MARITIME SAFETY COMMITTEE  
108th session  
Agenda item 19

MSC 108/19  
22 December 2023  
Original: ENGLISH  
Pre-session public release:

### Comments on the review of the North Atlantic wave data

Submitted by ICS, INTERTANKO, INTERCARGO and RINA

**Figure 1: The extent of the sea areas included within the IACS Rec.34 Rev.1 data**

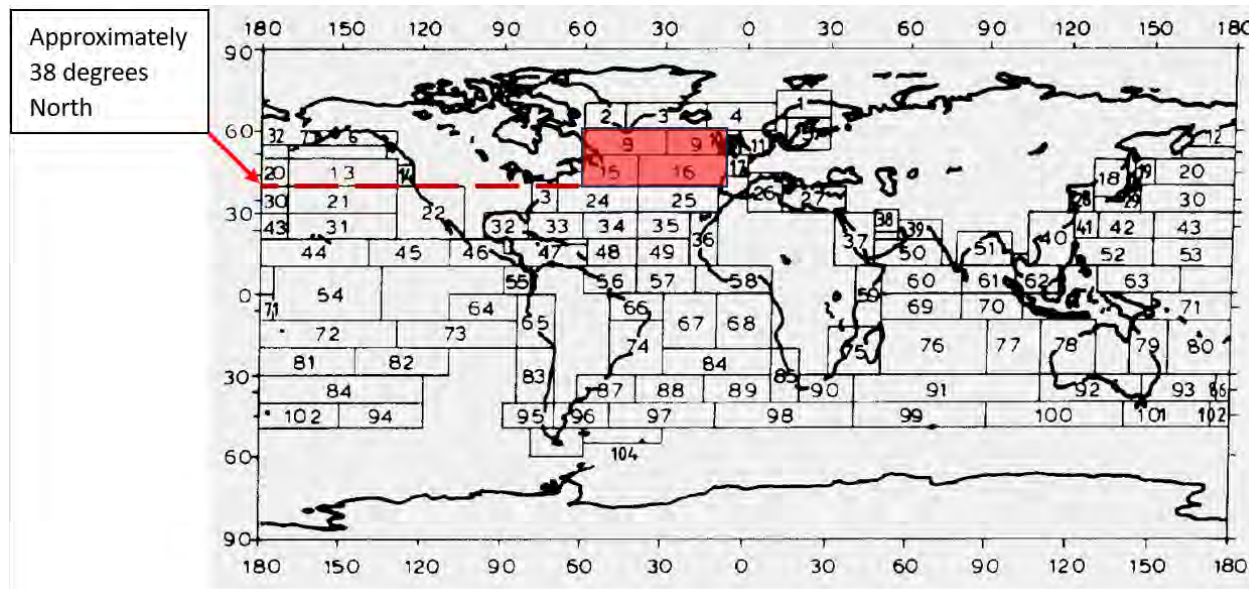
13 The Rev.1 wave data is based on sea areas 8, 9, 15 and 16. Figure 1 below is extracted from global wave statistics (BMT, 1986) and the shading has been added by the co-sponsors to indicate the included sea areas. As can be seen, these extend as far south as 38 degrees north.

**Figure 2: The extent of the sea areas included within the IACS Rec.34 Rev.2 data**

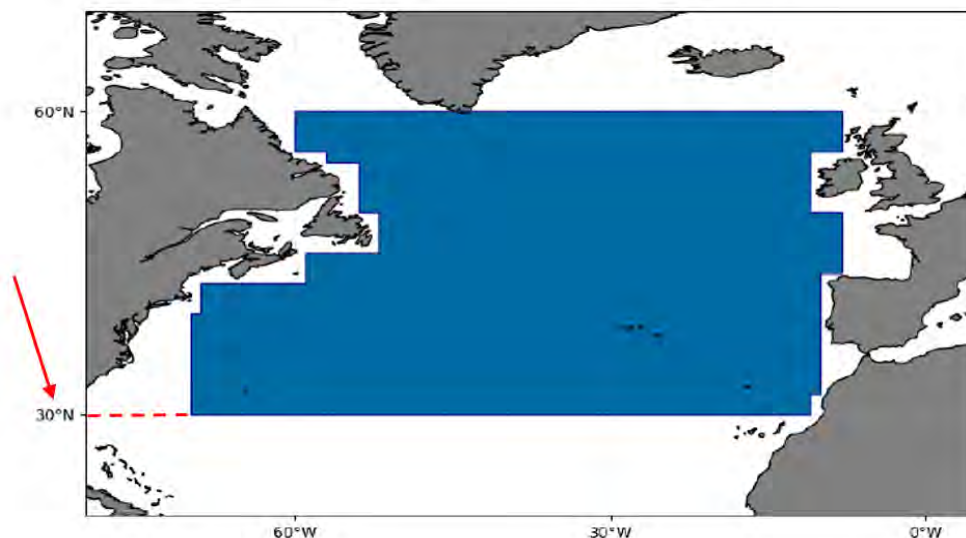
14 In comparison, figure 2 is extracted from Rev.2 and shows the extent of sea areas considered by the revised wave data. This revised area extends as far south as 30 degrees north, i.e. about 420 miles further south. This additional area extends from the southern part of Spain and nearly as far south as the Canary Islands.

16 However, when the co-sponsors refer to paragraph II.2 of resolution MSC.287(87), there is only a reference to "North Atlantic environmental conditions", and the sea areas are not listed. Therefore, the co-sponsors are unclear where the decision to add sea areas 24 and 25 to Rev.2 was initiated.

**Figure 3: Sea areas utilized for Rev.1.**

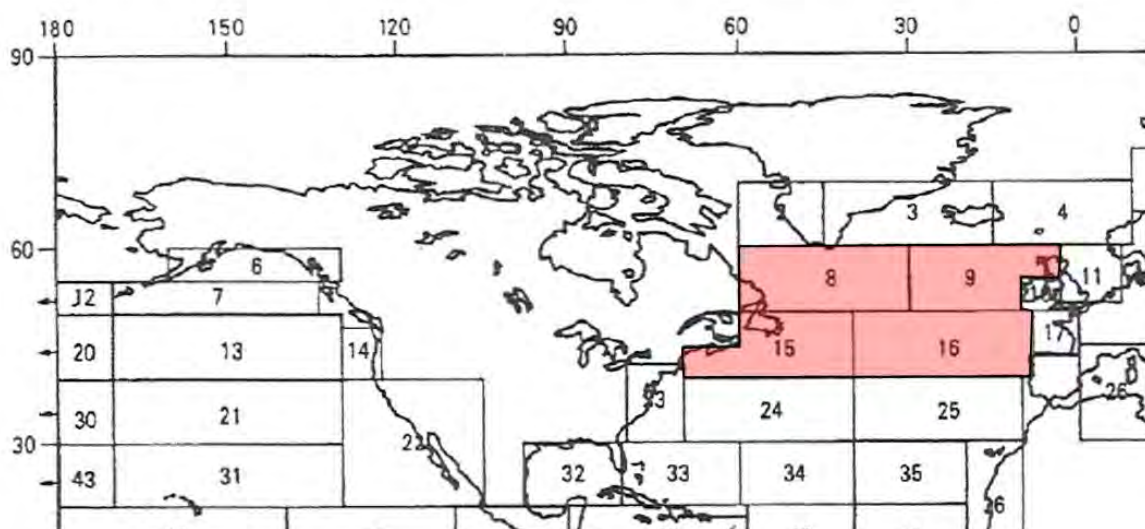
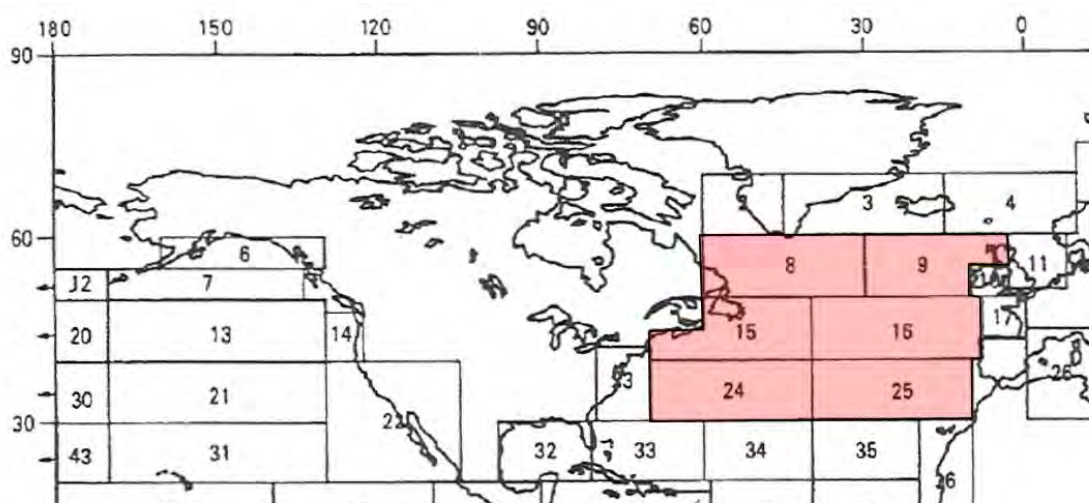
17 For clarity, the co-sponsors have shaded the respective areas adopted for the two sets of wave data on the below sea area charts:

18 Heading towards the equator, the general trend is for the significant wave height to reduce, and therefore extending the sea area further south will have included data that is less onerous than for the Rev.1 data. For example, (Phillippe Gleizon et al. , 2017), includes the contour plot reproduced in figure 5 below, which demonstrates a clear reduction in mean significant wave height when moving from 60 degrees north to 30 degrees north:

19 It is not clear to the co-sponsors why the area has been extended and now includes an area that is clearly less onerous than previously considered. The co-sponsors are again concerned that this approach is not consistent with wave data that should be representing global worst-case conditions.

**Figure 6: Histogram of wave height versus number of waves**

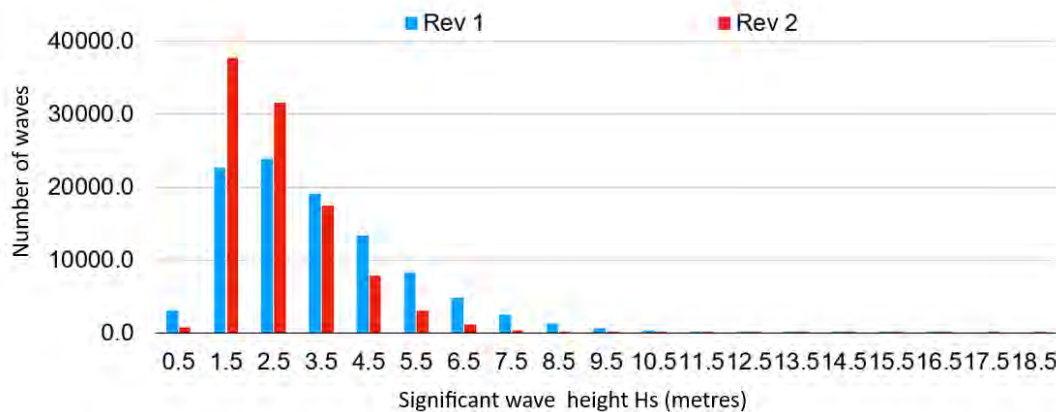
21 Although the total number of waves in each scatter diagram is the same, it is apparent that for the new data there are proportionately more waves of low to moderate wave heights, and proportionately fewer of moderate to extreme wave height.

**Figure 7: Contours of mean significant wave height (metres) for the Atlantic Ocean (Phillippe Gleizon et al. , 2017), with the mean values for Rev.1 and Rev.2 overlaid.**

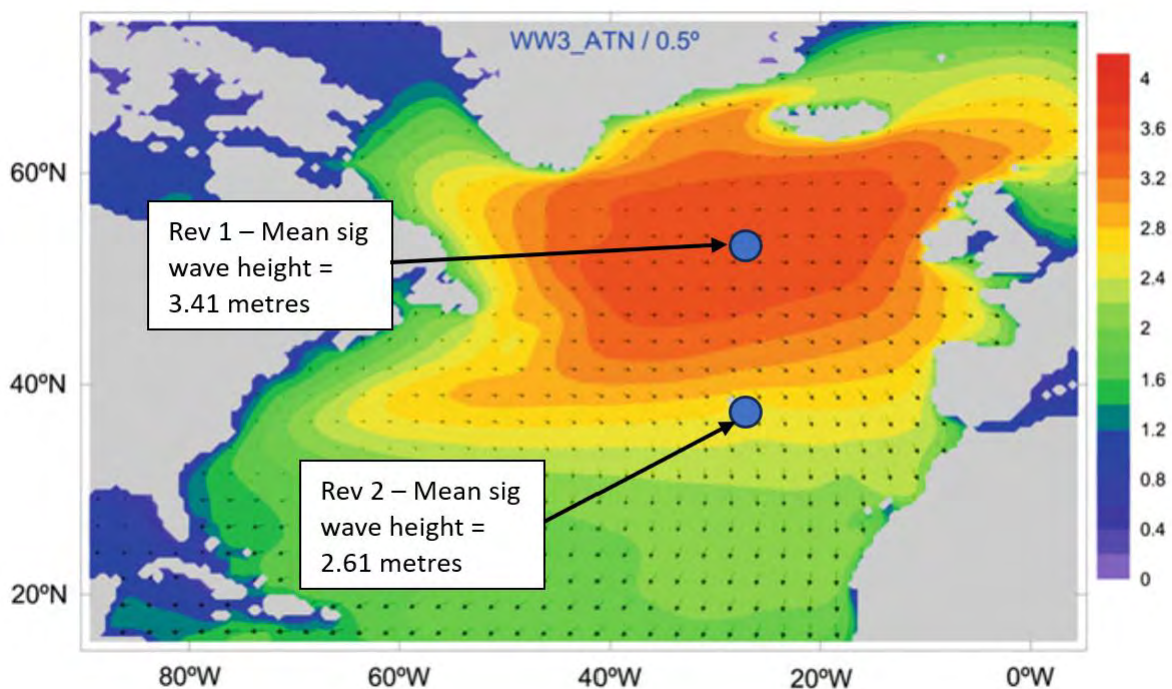
24 Although the Rev.1 data mean significant wave height is consistent with a North Atlantic location, the co-sponsors conclude that the Rev.2 data is of a magnitude more usually associated with a significantly more southerly location, and therefore cannot represent the worst case for structural design.

**Figure 8: Contours of 100-year wave height (metres) (UK HSE, 2005)**

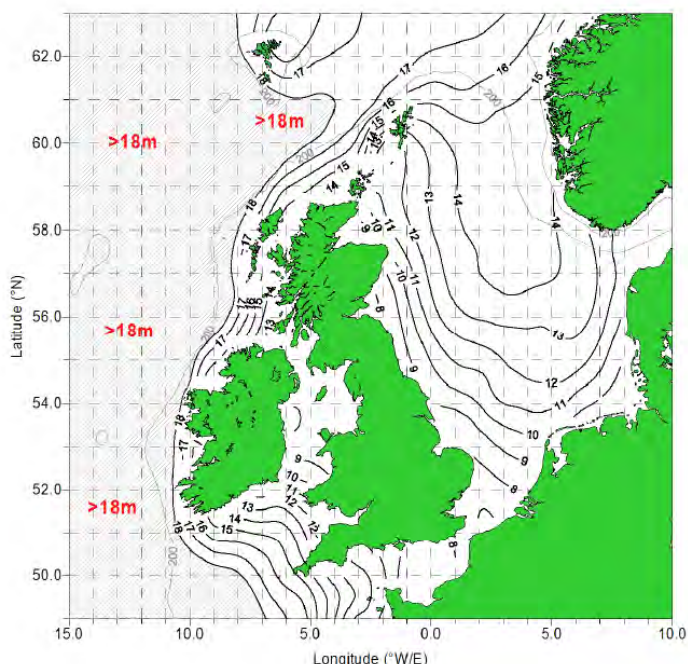
26 Considering just the 100-year significant wave height, and as a benchmark, referring to the 100-year wave height contours displayed in figure 8,<sup>2</sup> the difference between 17.57 metres and 14.33 metres is equivalent to the difference in metocean conditions experienced off the Shetland Islands and central North Sea. These two regions would normally be considered to have distinctly different metocean environments. For comparison, if two identical fixed floating installations were deployed to these locations (e.g. an FPSO) they would be expected to have markedly different performance in terms of hull fatigue.

28 It should also be noted that figure 8 is indicating maximum 100-year significant wave heights off the continental shelf of greater than 18 metres, which of course is in excess of either the Rev.1 data (17.57 metres) or the Rev.2 data (14.33 metres).
